Agenda Item III.4

TOWN OF BRISTOL
Application for Driveway Access Permit to a Town Highway

Application #: 20-03DA

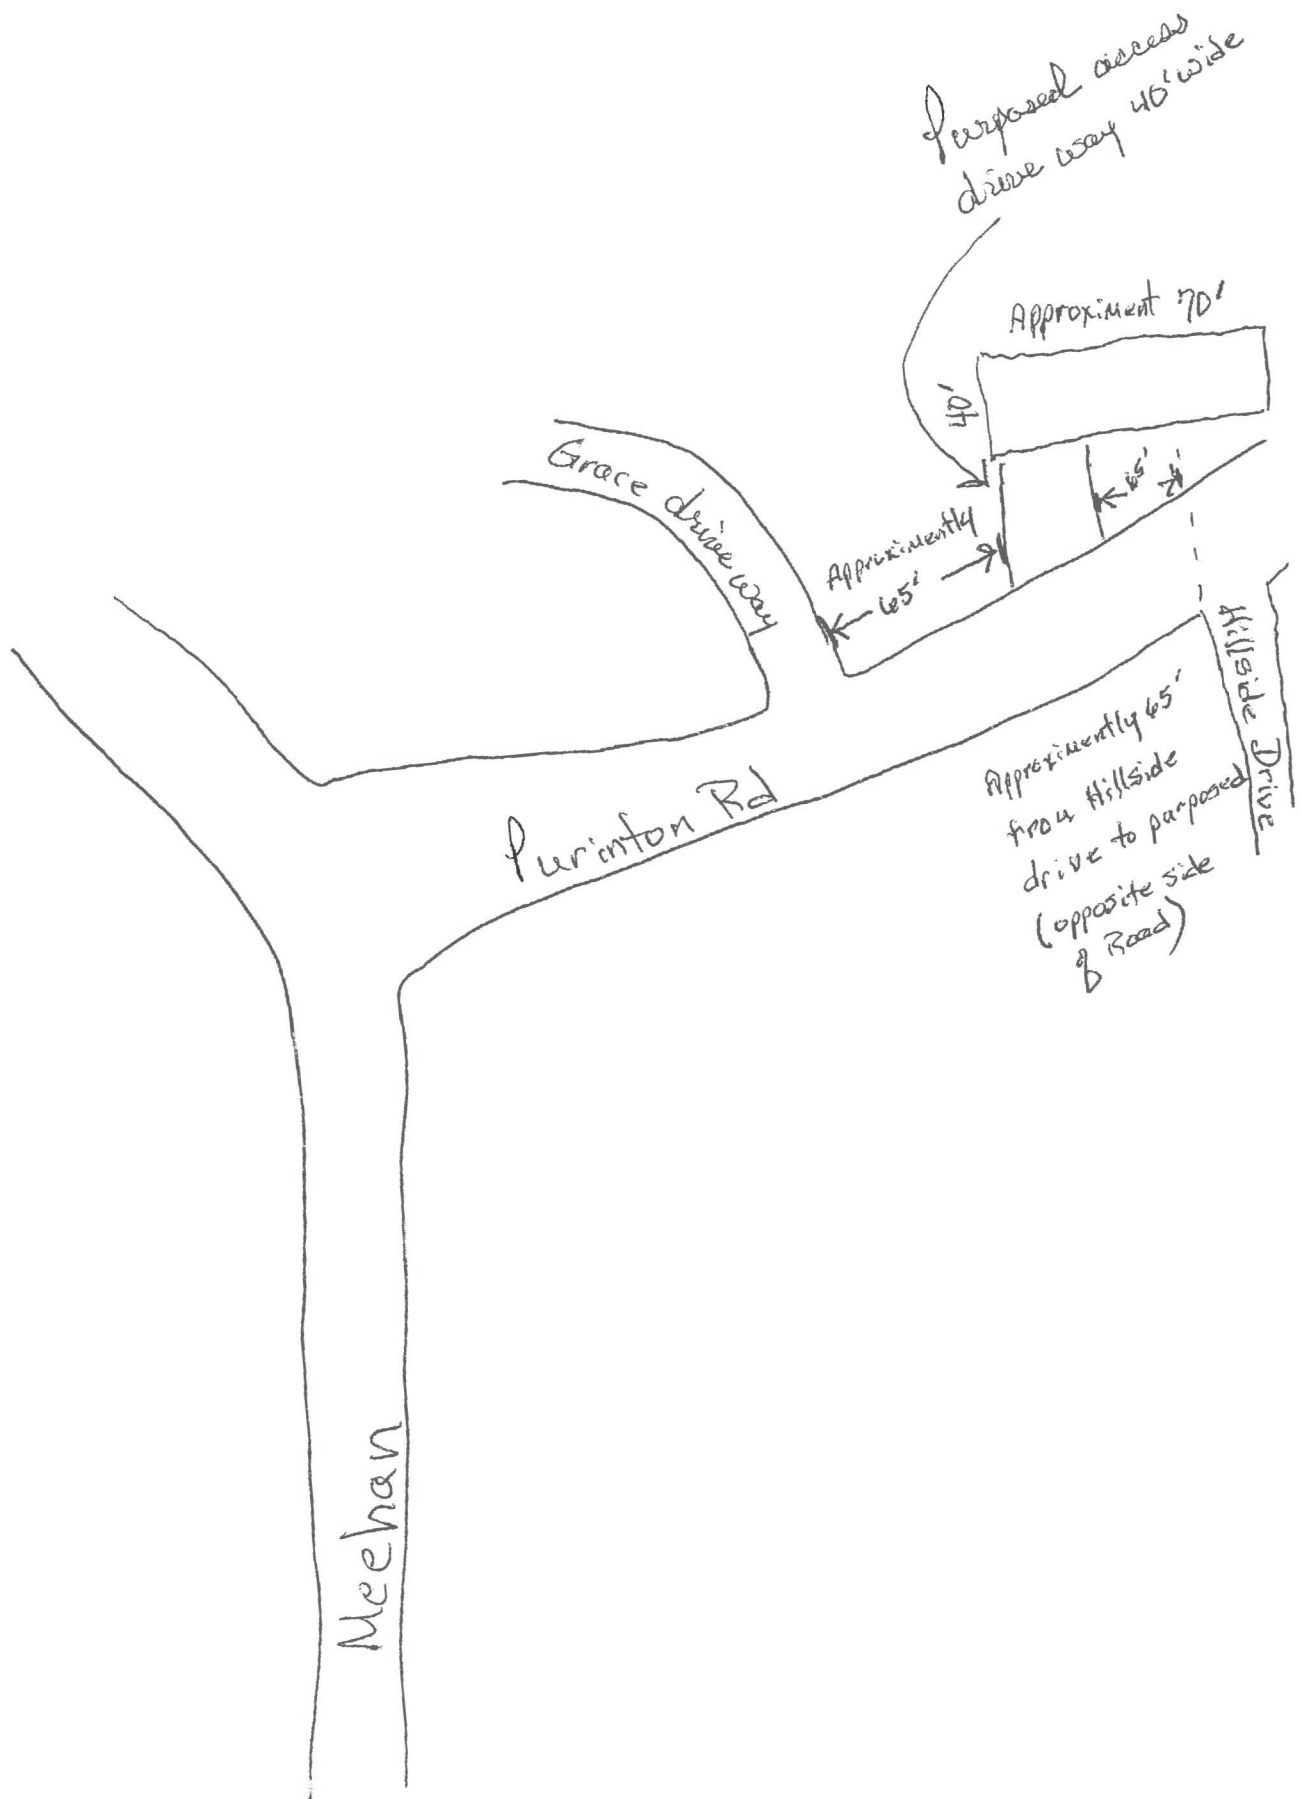
Must install a 15" x 40' culvert for access of 109
trucks, plastic pipe (Black) minimum of 12" of cover, (grey)
plastic 6" minimum of cover, ditch both sides to allow water
in and out, may have to cut some trees to the south
depending on sight. ~~Access~~ ^{access} needs to access the road flat
for 17' back. (Cover material on culvert shall be crush gravel
compact with a suitable compactor in 12" lifts,
